The Corporation of the
Town of Milton
Committee of Adjustment and Consent

Thursday, March 26, 2026, 6:00 p.m.
Council Chambers - In Person

Report To: Committee of Adjustment and Consent

Subject: 11319 Derry Road

Figure 1 – Site Plan

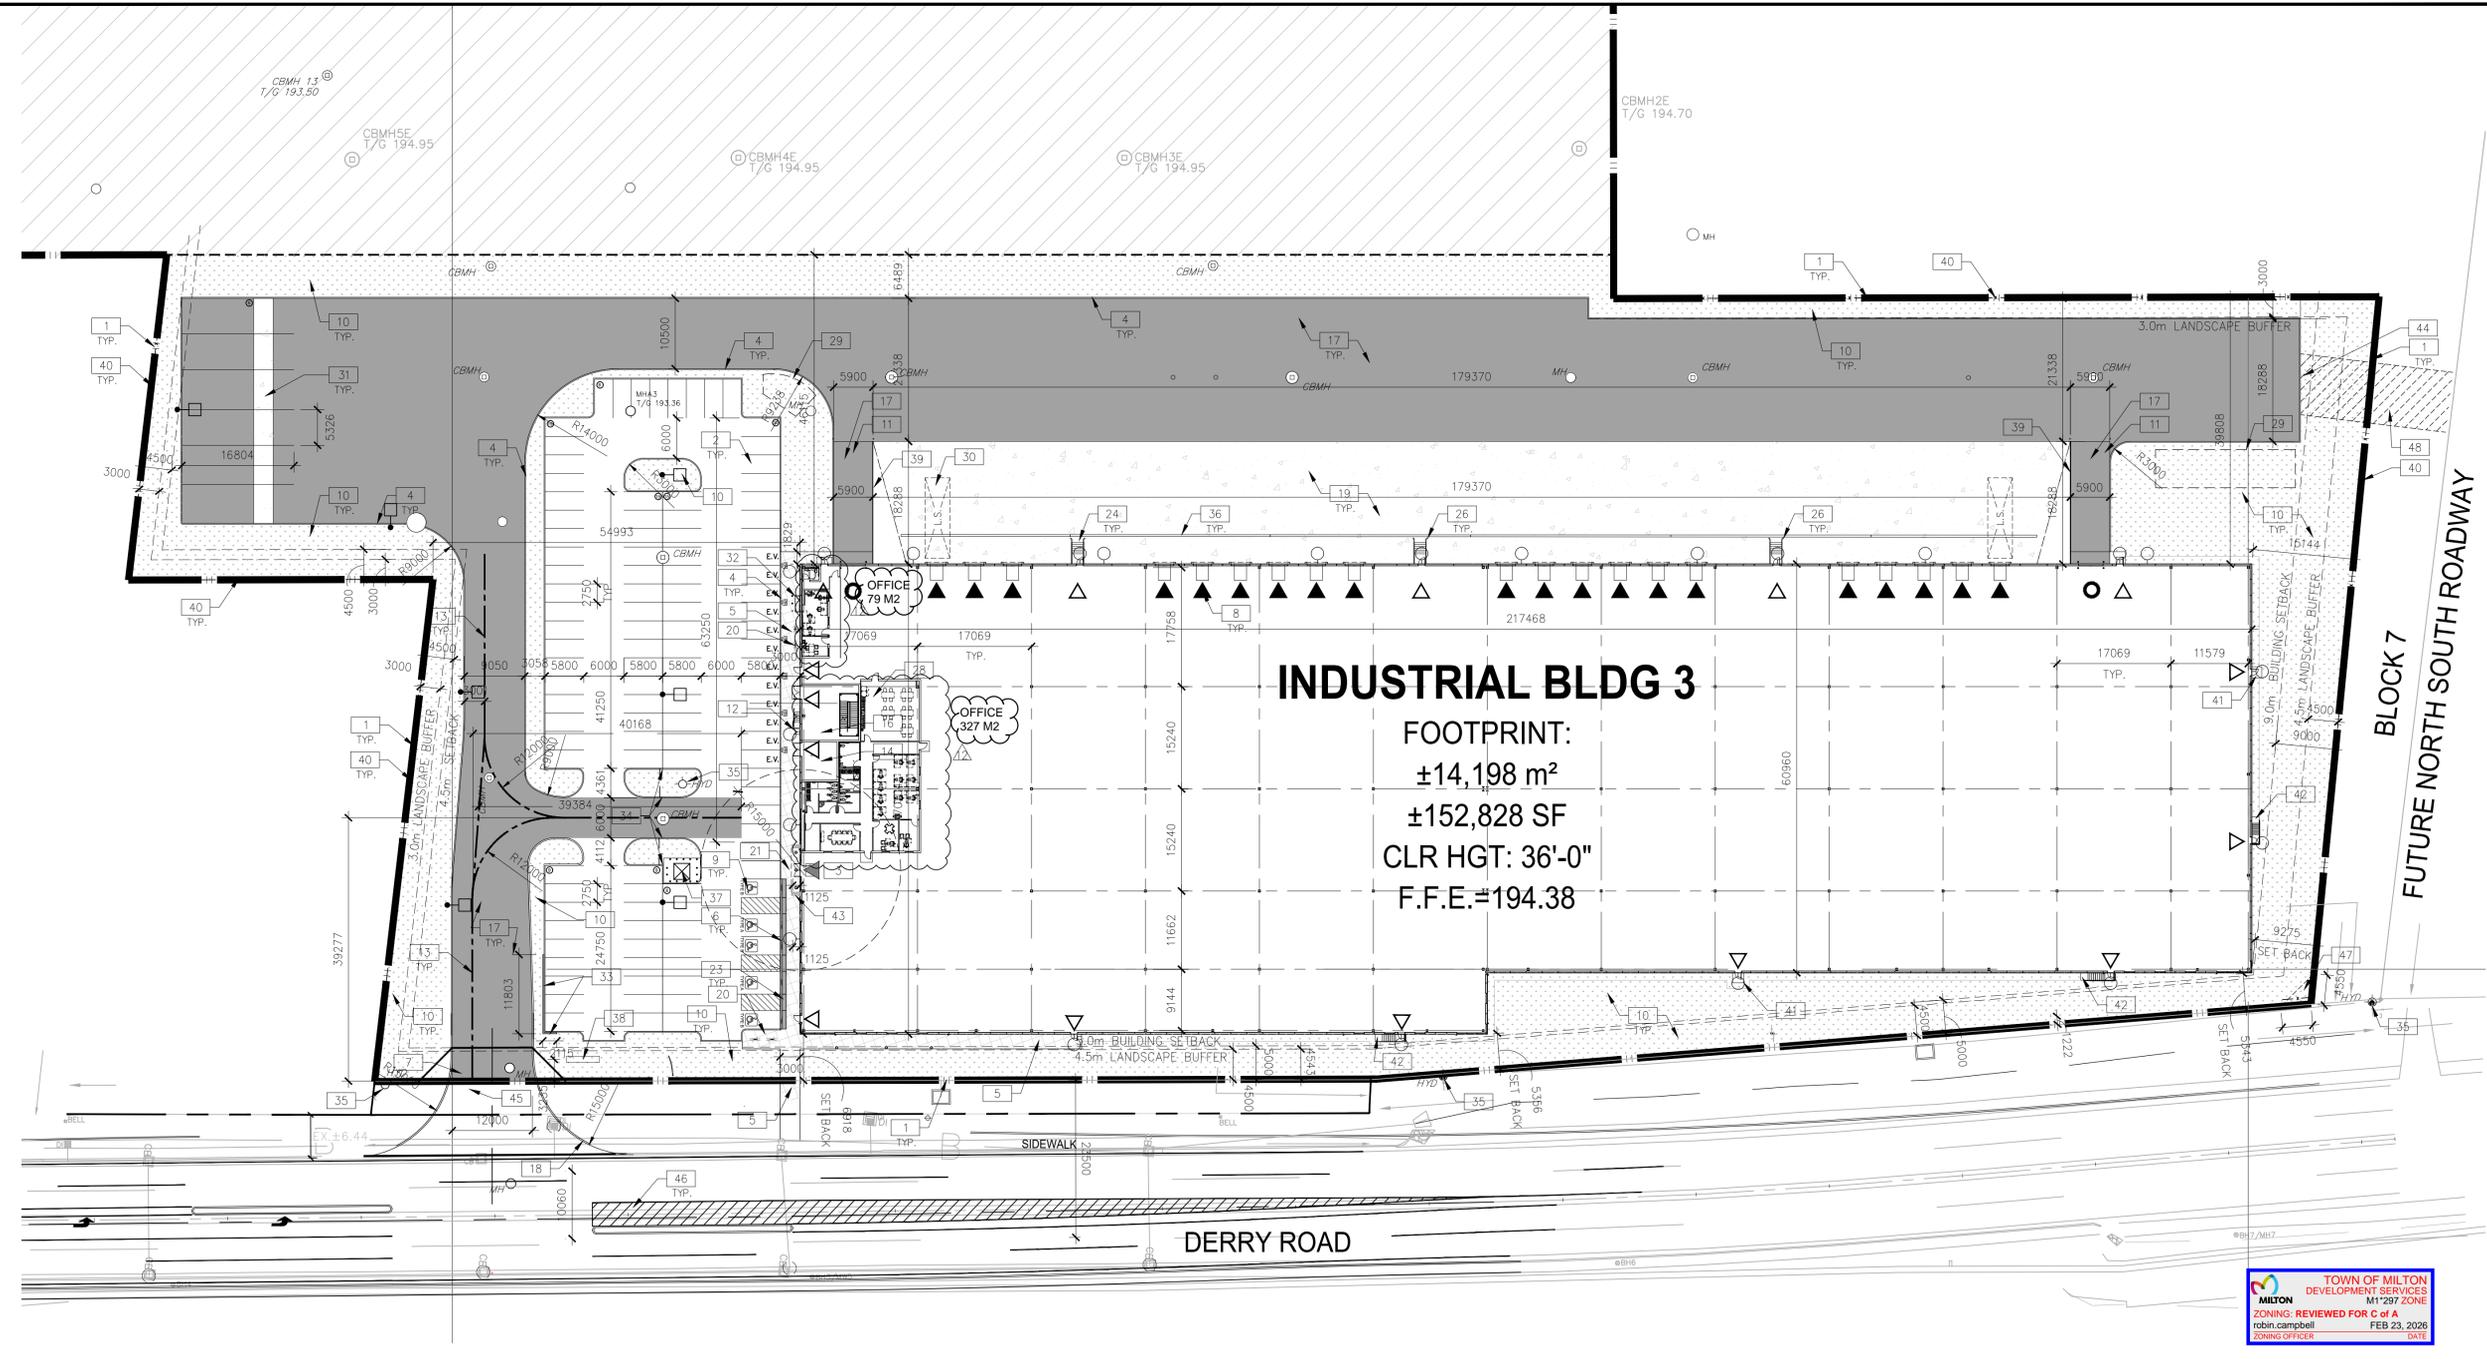
The application seeks to reduce the required office component to a minimum of 2% of the GFA of the building, resulting in a minimum office GFA of 406 square metres. Zoning Exception 297 (approved in 2021) required that for any industrial use, warehouse, distribution centre, or wholesale operation, a minimum of 15% of the total building GFA shall be dedicated to an office component. In January of 2024, a minor variance was approved to reduce this requirement from 15% to 10% of the GFA. The applicant has submitted the current minor variance application as the tenant of the building requires additional warehousing GFA, and less office space.

As the proposed variance will only affect the internal layout of the building, the application will have no negative impacts on neighbouring properties. In addition to facilitating an appropriate use of the building, the application is desirable as it will permit a distribution of uses consistent with Provincial direction for Areas of Employment.

1. THAT the development shall be constructed generally in accordance with the site plan prepared by Ware Malcomb and dated and stamped by Town Zoning on February 23, 2026

1 SITE PLAN
 SPI SCALE: 1"=12'-0"

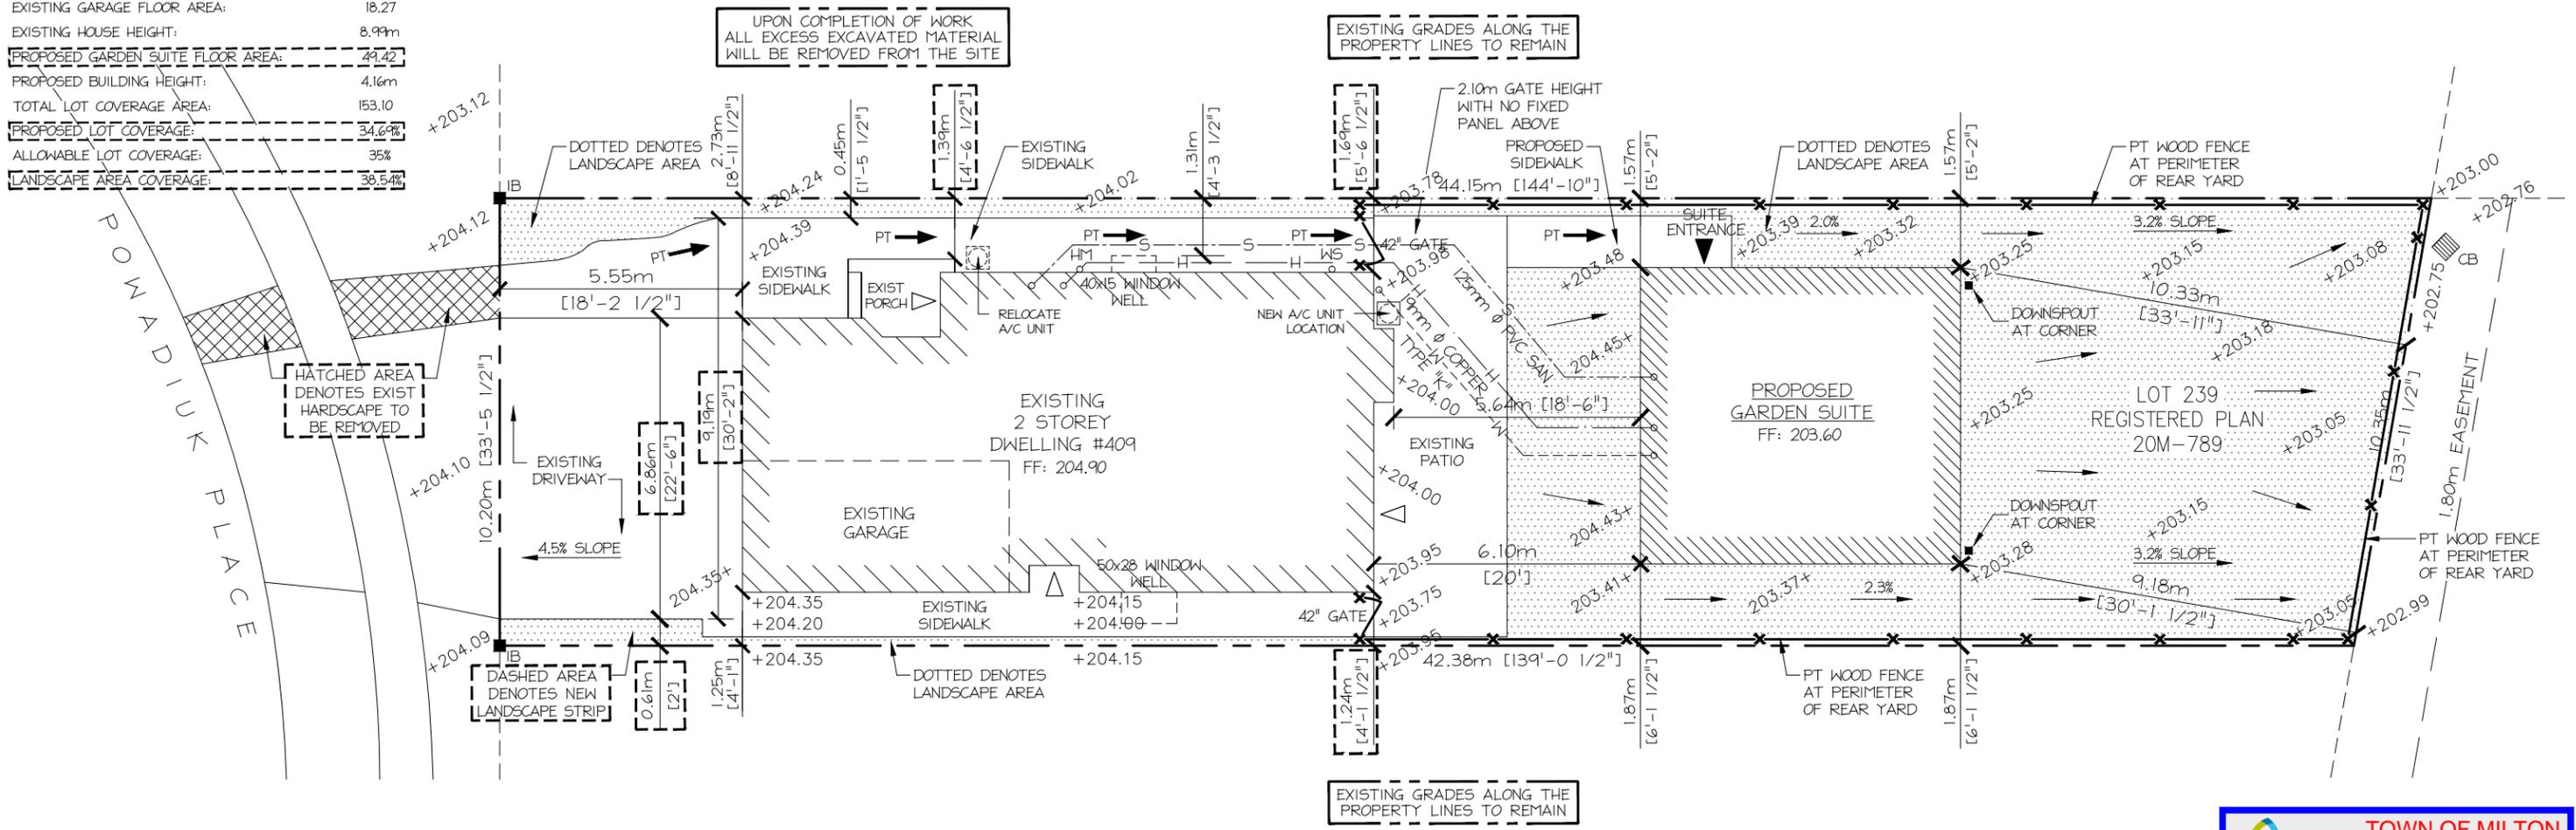
In response to comments from Development Engineering, grading and downspout details have been added to the site plan. Development Engineering has also requested the removal of certain hardscaped areas, which has been implemented through the recommended conditions.

As the Subject Property has a frontage of 10.2 metres, the existing driveway extends over the majority of the front yard. This driveway width causes negative visual impacts, limits opportunities for plantings and water filtration, and enables a parking configuration which could obstruct circulation on the Subject Property. In its current configuration, the driveway allows a vehicle to park in the path of travel leading to both the entrance of the primary unit and the proposed rear yard ARU, raising functionality concerns. Given the adverse impacts of the existing condition, the proposed variance is not minor or desirable.

In addition, the existing driveway width does not maintain the general intent and purpose of Official Plan policies which call for development to retain vegetation and naturalized space, create a safe and attractive community, and provide a high quality of urban design. Moreover, the Official Plan directs development to provide a high quality streetscape design and enhance the sense of place. Variance Two would instead limit vegetation and soft landscaping on the Subject Property, leaving little room for a front yard. The existing driveway width allows for vehicles to be parked across nearly the entire frontage of the Subject Property, which not only detracts from the streetscape, but may also compromise pedestrian circulation.

For these reasons, the proposed variance is not minor, not desirable for the appropriate use of the land, building, or structure, and does not maintain the general intent of the Zoning By-law or Official Plan. Planning staff recommend that Variance Two be denied.

1. That the development shall be constructed generally in accordance with the site plan prepared by Midtown Technical Services and dated and stamped by Town Zoning on March 12, 2026.

2. That a Building Permit be obtained within two (2) years from the date of the decision.
3. That prior to registration of the ARU, a minimum vertical clearance of 2.1 metres shall be provided for the gate in the northern interior side yard, in accordance with the attached site plan.

Attachments
Figure 1 - Site Plan/Severance Sketch

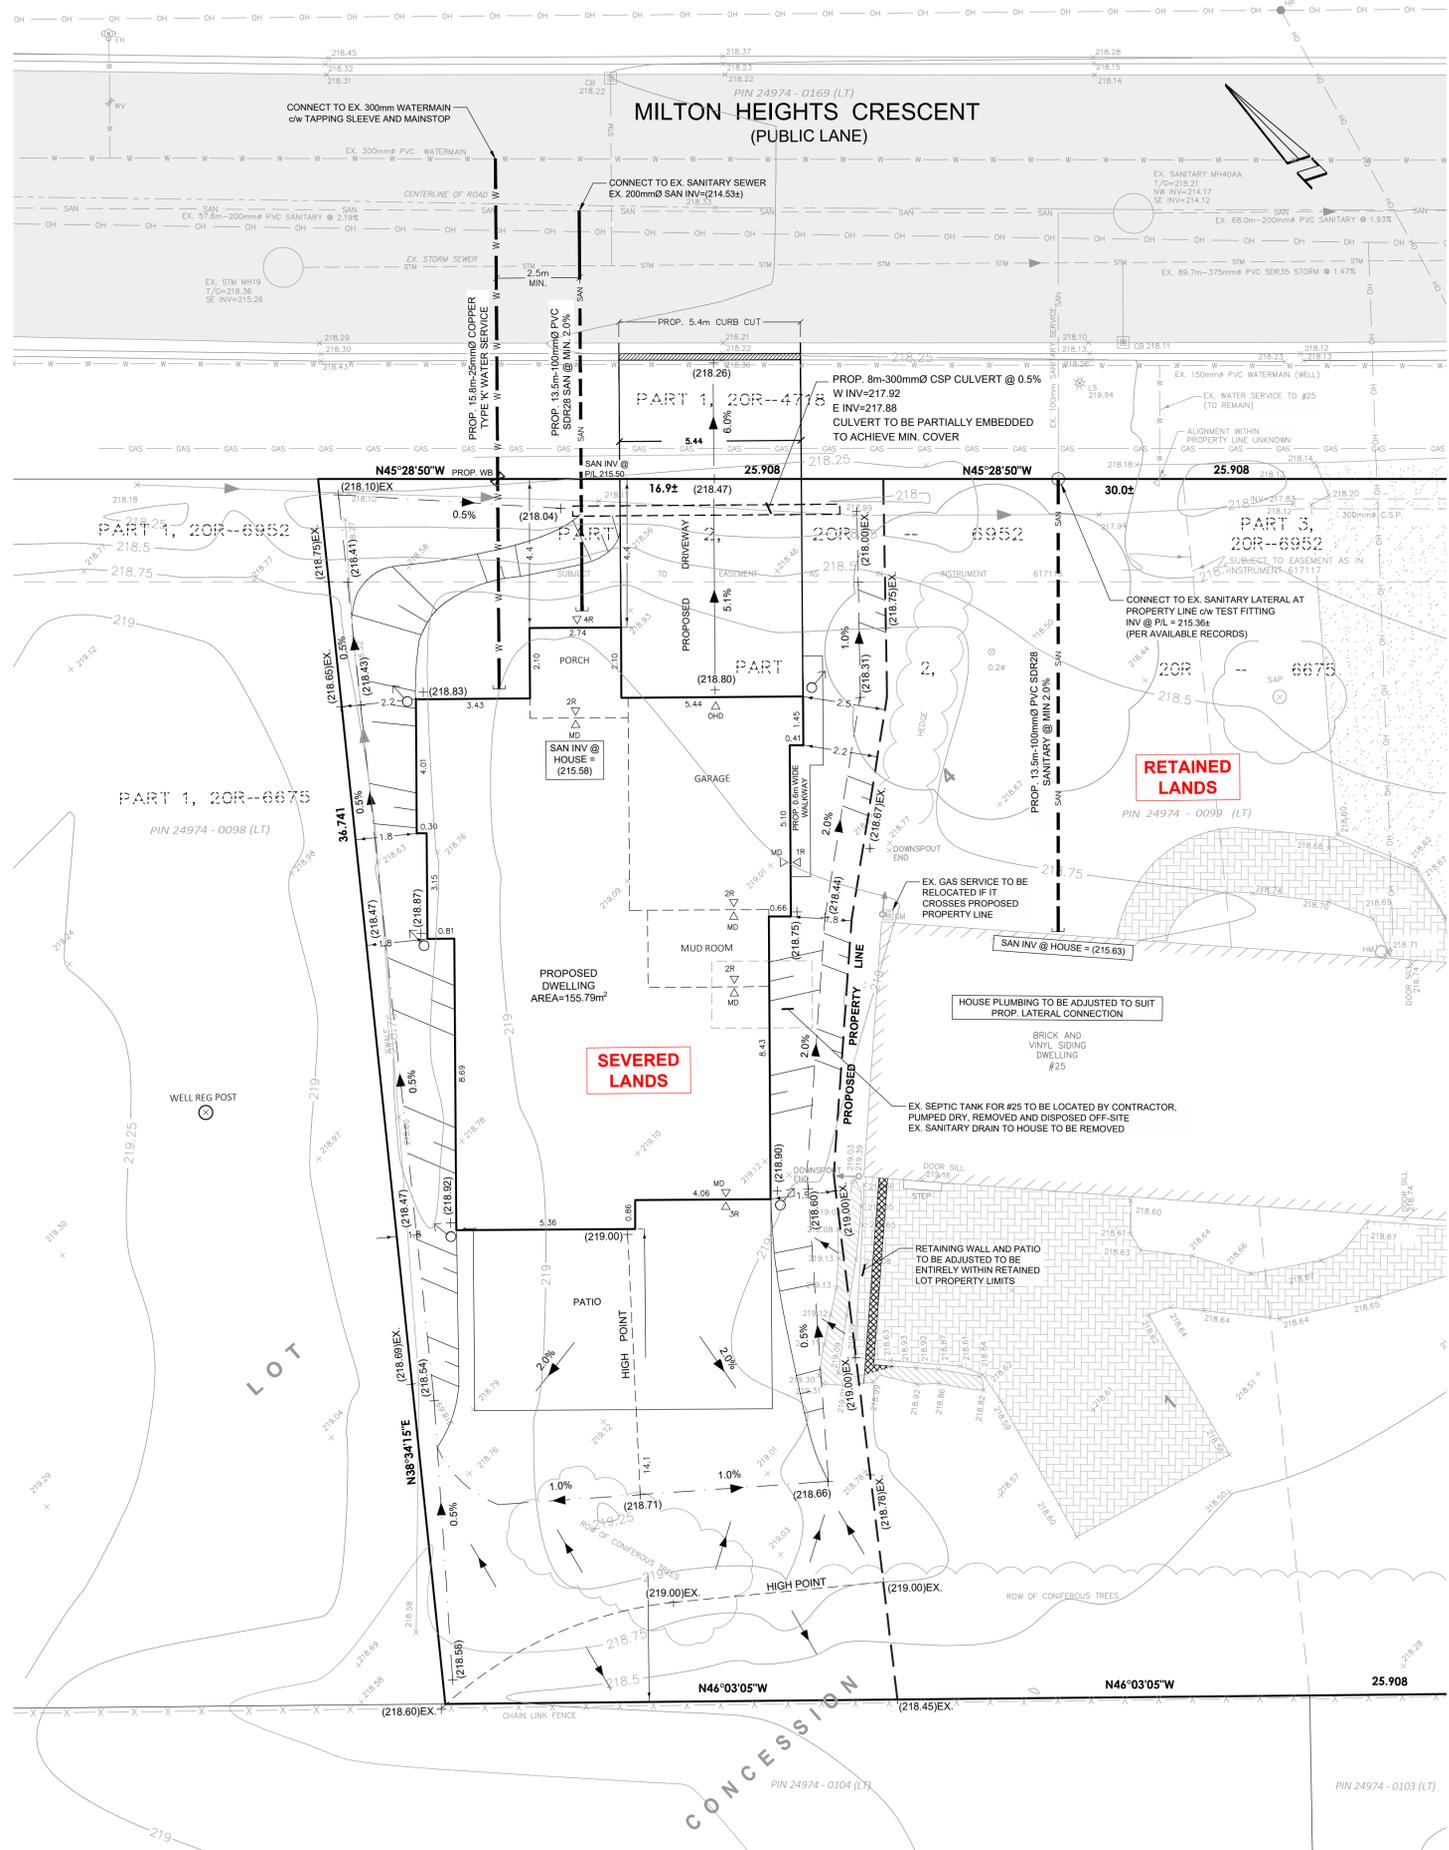
Town Engineering staff had requested a detailed Grading Plan to ensure that stormwater management and drainage would not impact the severed lot. This was received and met Town standards for the consent and minor variance applications to proceed. Further, Town Engineering Staff have requested that the applicant provide a schedule of works required to relocate/modify the existing rear patio and retaining wall so that these features are located entirely within the limits of the retained lot. This has been included above as a condition of development approval and the applicant is aware of this requirement.

Engineering staff worked with the applicant to ensure drainage was satisfactory and the applicant provided a detailed Grading Plan that demonstrated the downspout locations will ensure the water will remain on the retained property. Further, Town Engineering staff do require some further details regarding relocating and modifying the existing rear patio and retaining wall and this has been included as a condition of development approval.

1. That the development shall be constructed in accordance with the site plan prepared by Van Harten Land Surveyors - Engineers and stamped by Town Zoning on February 9, 2025.
2. The applicant shall provide a schedule of works required to relocate/modify the existing rear patio and retaining wall so that these features are located entirely within the limits of the retained lot. All hardscape features, including retaining walls, shall maintain a minimum setback of 0.45m from any property line.
3. That a Building Permit be obtained within two (2) years from the date of the decision; and
4. That the approval be subject to an expiry of two (2) years from the date of decision if the conditions are not met, if the proposed development does not proceed and/or a building permit is not secured.
